ALAMEDA COUNTY
HEALTH CARE SERVICES

Subject: Fuel Leak Case RO0000335, Chevron #9-6607, 2340 Otis Drive,
Alameda, CA 94502

Alameda County Environmental Health has received and reviewed the April 18, 2005 *Regulatory Response and Investigation Workplan* from Cambria responding to our agency's March 21, 2005 on the referenced. Four borings are proposed to evaluate soil and groundwater concerns noted in our letter. Your work plan is approved, however, please address the following technical comments when performing the proposed work and submit the technical report requested below.

TECHNICAL COMMENTS

Proposed Soil Boring Locations

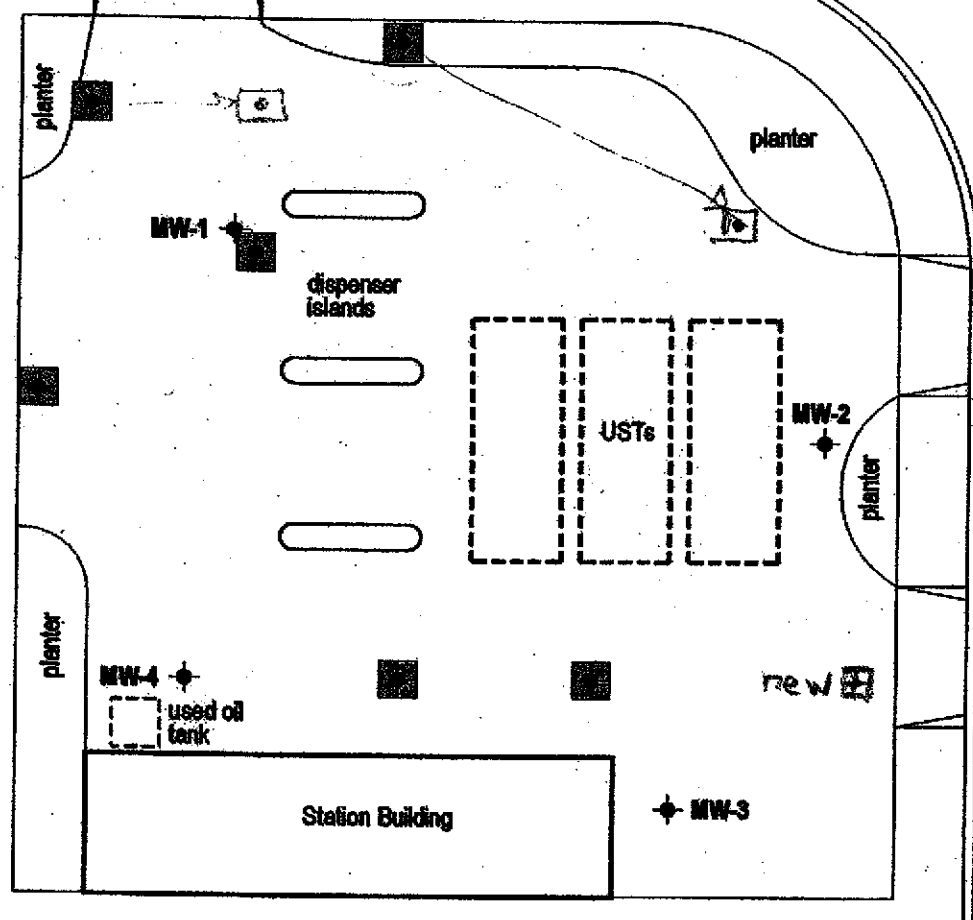
2. Soil Borings- the proposed borings are concentrated in the northern section of the property, however, the petroleum release (MTBE) has been observed over a much larger area of the site. Our office recommends a transect of borings immediately up-gradient of and down-gradient of the sources ie dispenser islands and USTs . This can be done with one additional boring and moving the locations of the two northernmost samples to the east. A modified Figure 2 is attached indicating these locations. We concur with the proposal to collect depth discrete soil and groundwater samples at 5 and 11' bgs, however, sampling should be sufficient to determine the vertical extent of contamination. A soil sample should be collected and analyzed at changes in lithology and in areas of obvious contamination. At least one boring from each transect should be advanced to 25'bgs to confirm the geology noted during the initial MW installations. Please prepare cross-section diagrams with the data generated. We concur with the proposed analytes.
